## **INFORMATION REQUEST**

**APPLICATION NO:** MCUI/22/2026  
**PROPERTY ADDRESS:** 3850-3858 MOUNT LINDESAY HIGHWAY, PARK RIDGE QLD 4125  
**PROPERTY DESCRIPTION:** LOT 3 SL 6300  
**APPLICATION DESCRIPTION:** WAREHOUSE

*Figure 1*

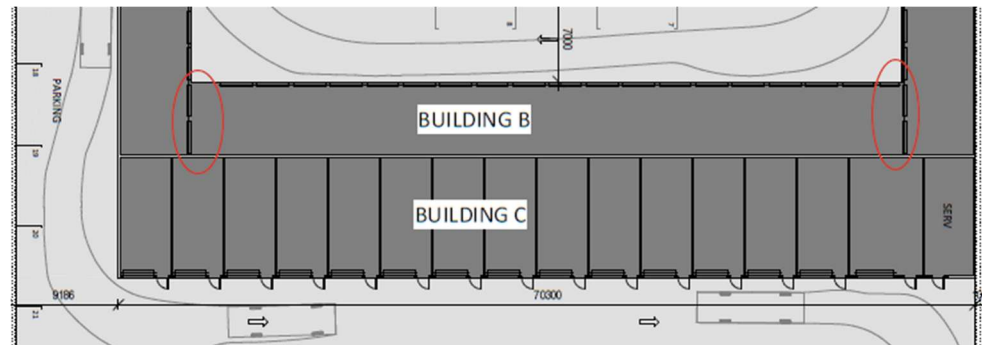
- 3.7. Provide an amended plan showing the location of all individual units within proposed Building B.
- 3.8. Confirm how access to the below storage units (circled in red on *Figure 1*) will be facilitated, as it does not appear that access can be obtained unless accessed from another storage unit.
